DATE: **May. 9/03****V2500-A1 SERIES NACELLE SERVICE BULLETIN**

This document transmits the Initial Issue of Service Bulletin NV2500-78-0208

NACELLE – EXHAUST – COMMON NOZZLE ASSEMBLY (CNA) – ADDITION OF NUTPLATES FOR  
ATTACHMENT TO ENGINE

CNA Attach Ring Nutplate Installation  
Figure 1

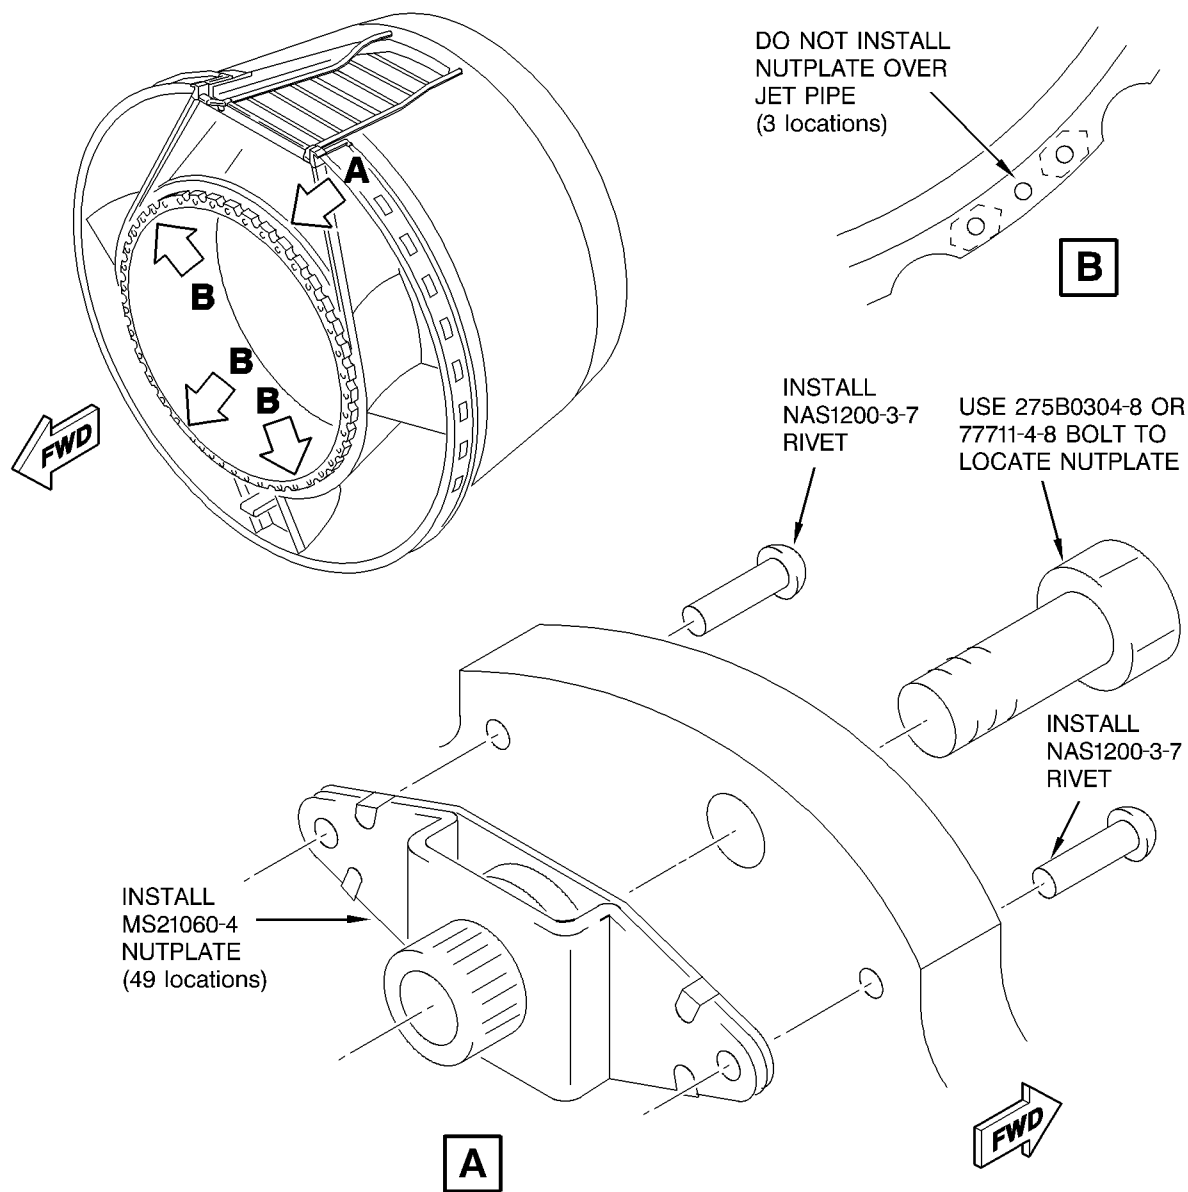
- (1) Clean the flange with a lint free cloth (CoMat 02-099) made moist with solvent (CoMat 01-438). Wipe the surface dry before the solvent becomes dry.
- (2) Make the holes for the nutplate attach rivets. Refer to Figure 1 for nutplate positions. Use a 275B0304-8 or 77711-4-8 bolt to hold the nutplate in position while you make the holes for the rivets. Do not install nutplates over the three jet pipe holes. Refer to Figure 1.
- (3) Install the 49 MS21060-4 (or S700N1362-4) nutplates on the flange with the NAS1200-3-7 rivets. Refer to Figure 1.

CNA Installation - Before Modification  
Figure 2 (Sheet 1)

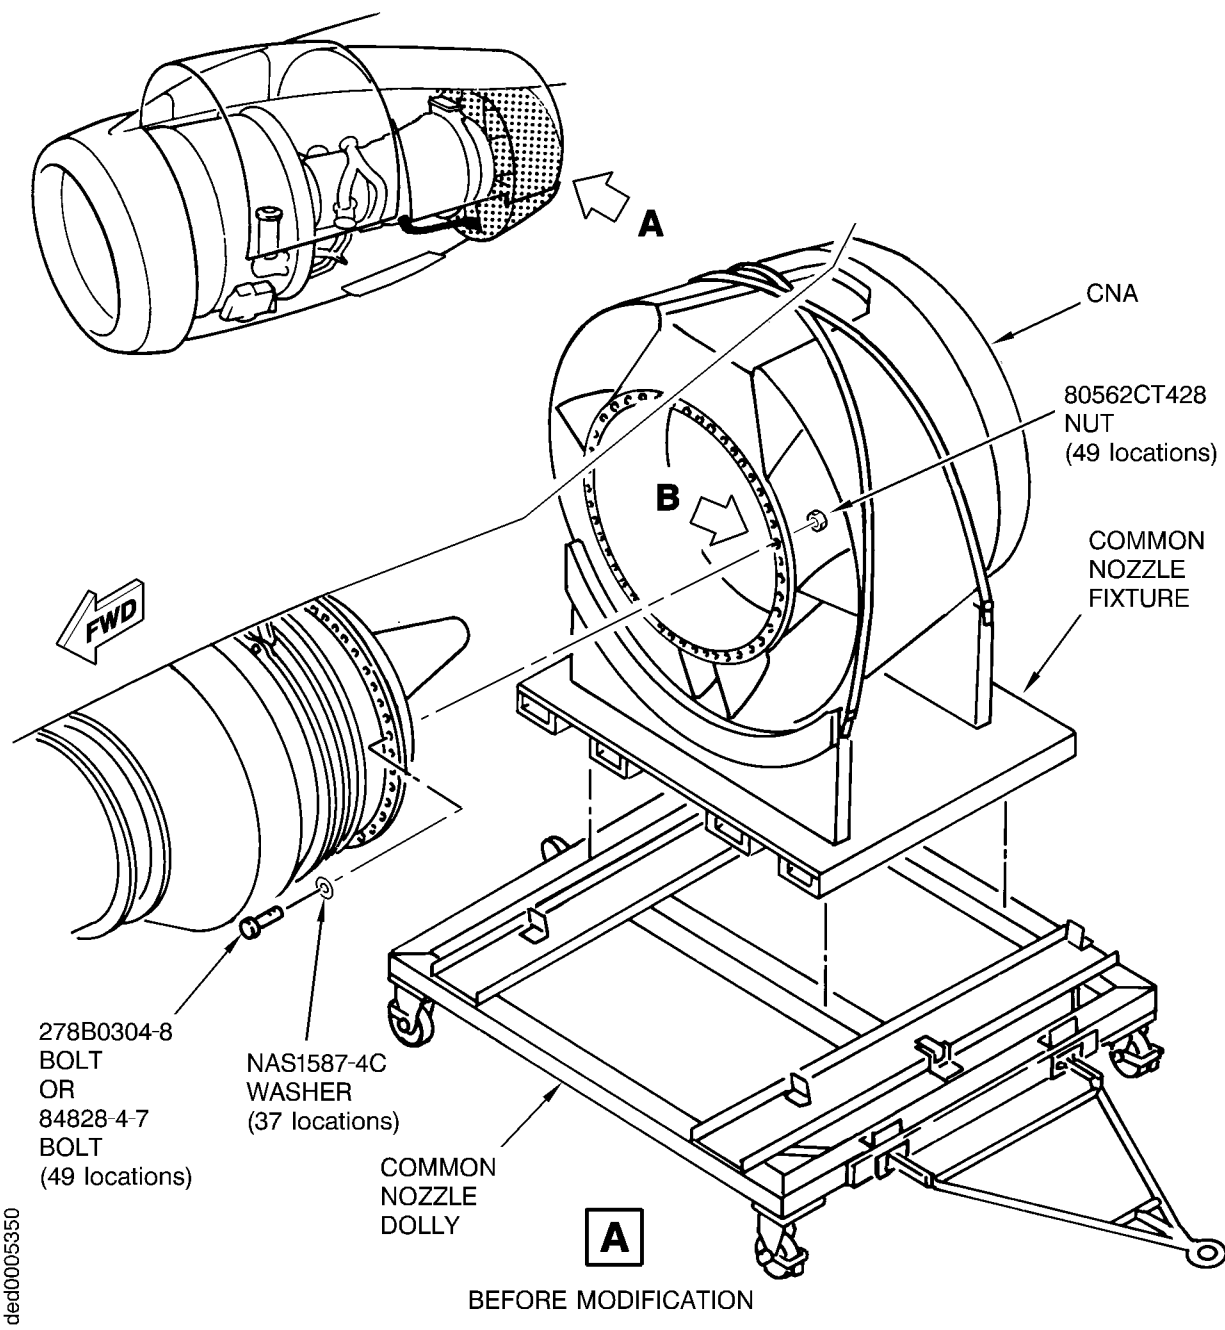
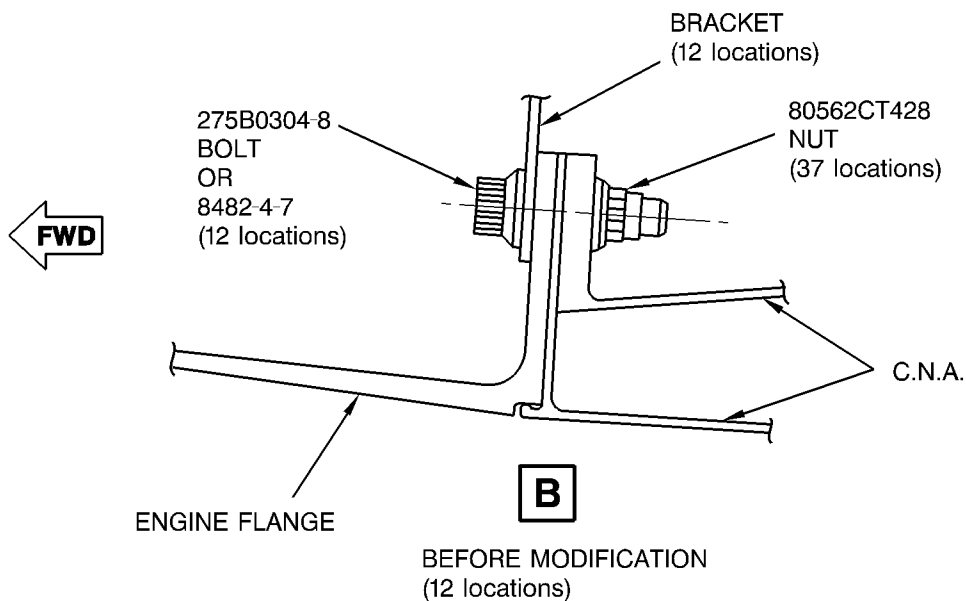
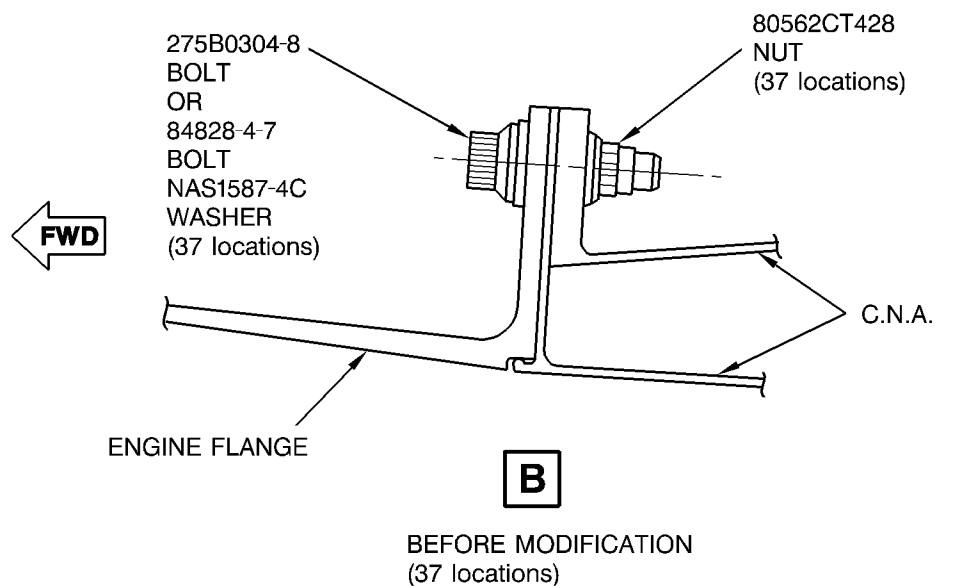
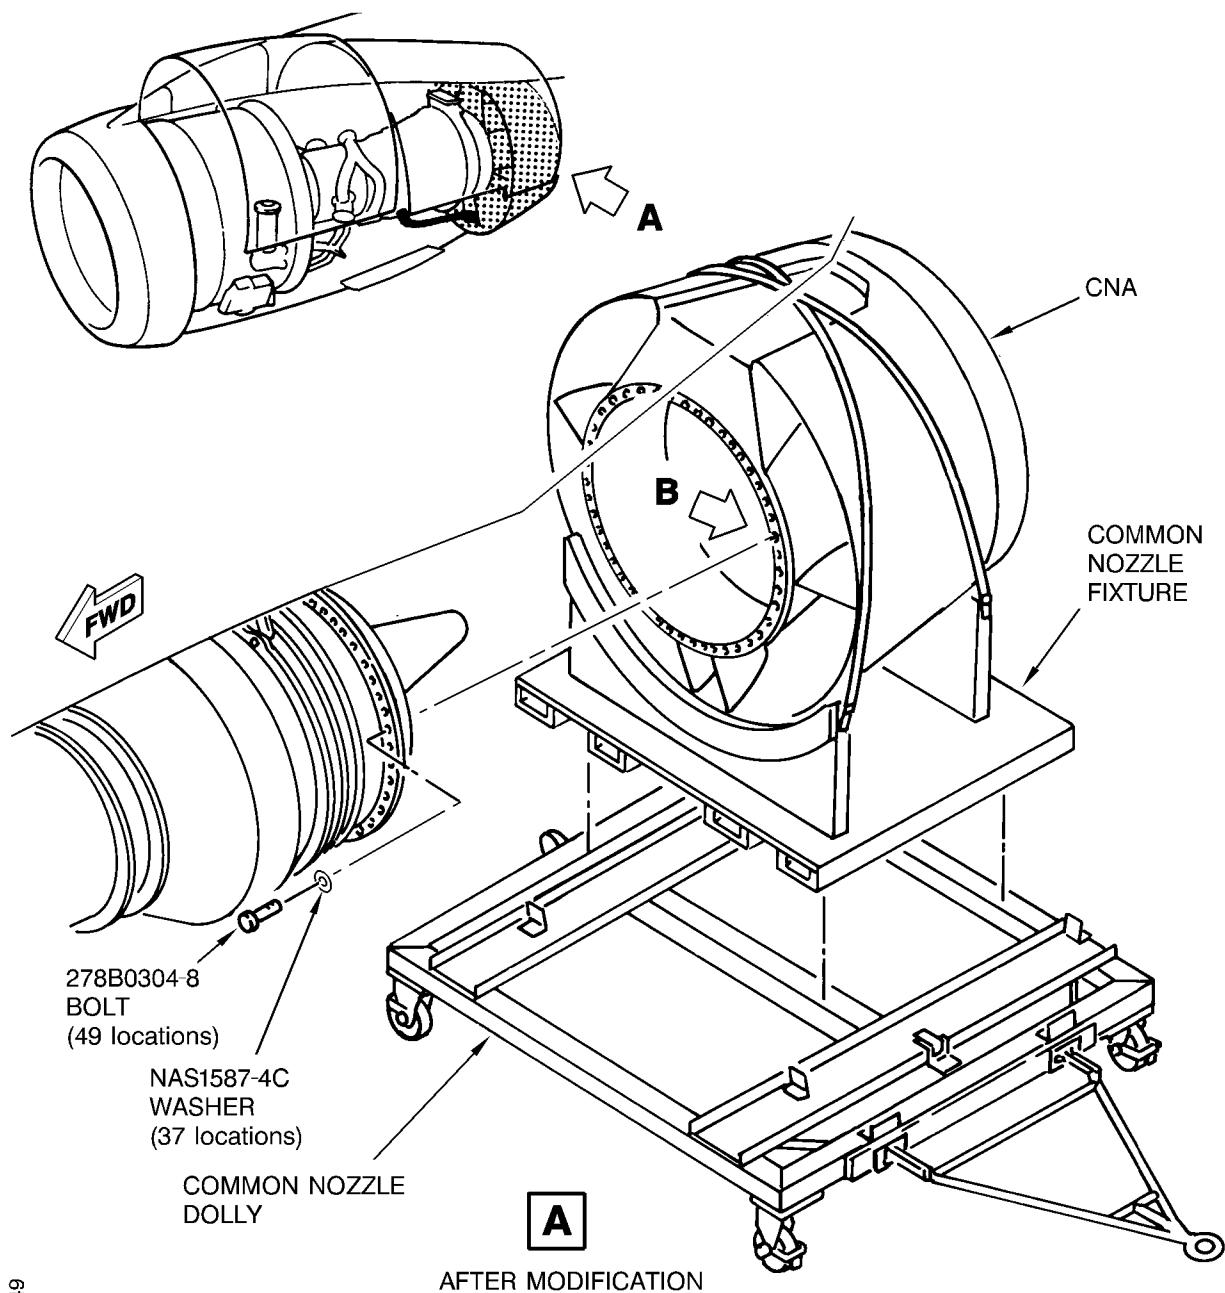
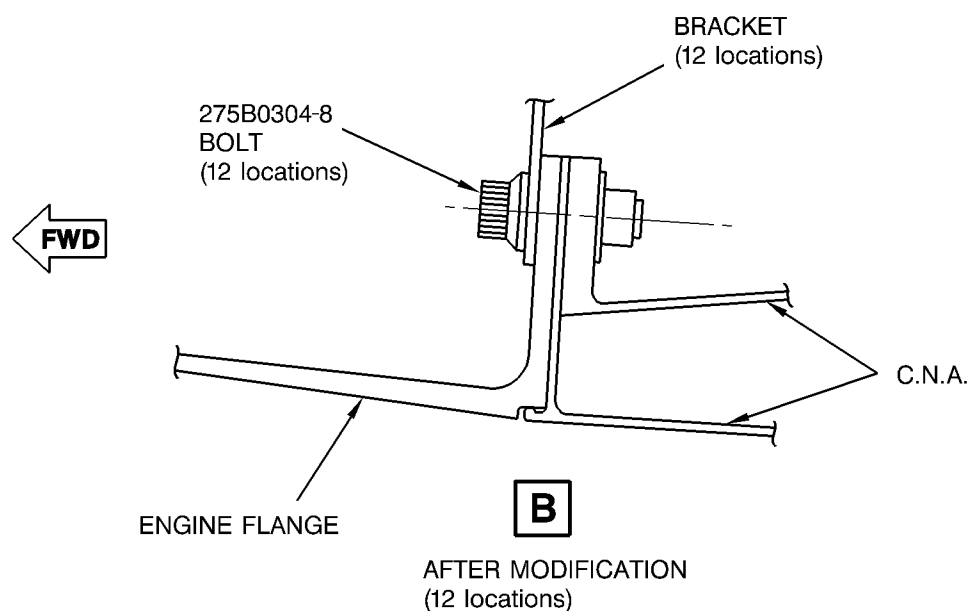
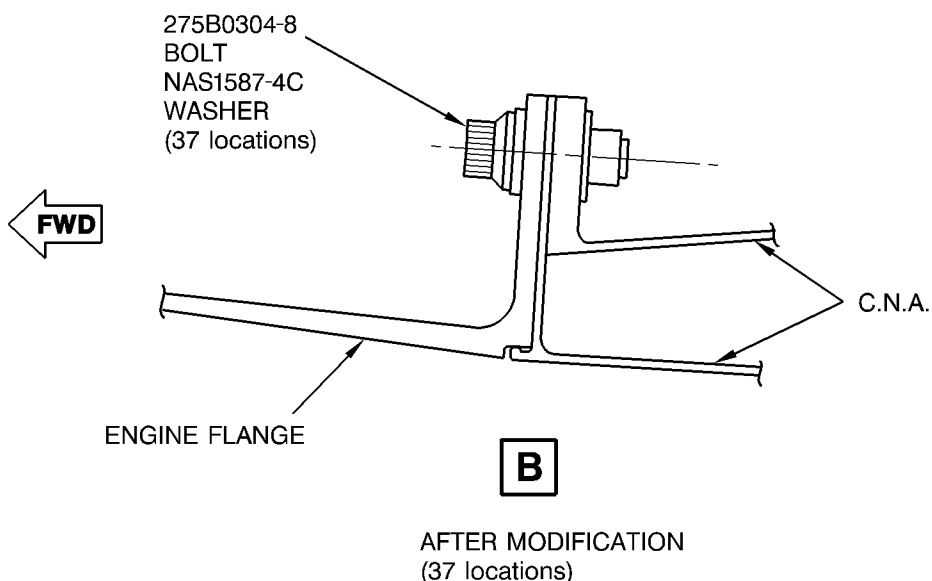
**NOTE:** Before you modified the C.N.A. as instructed in this bulletin, the C.N.A. attach bolts may have been part number 84828-4-7 or 275B0304-8. After modification the C.N.A. attach bolts must be 275B0304-8 or 77711-4-8.

- (1) Refer to Figure 2 for C.N.A. installation before modification.
- (2) Refer to Figure 3 for C.N.A. installation after modification.
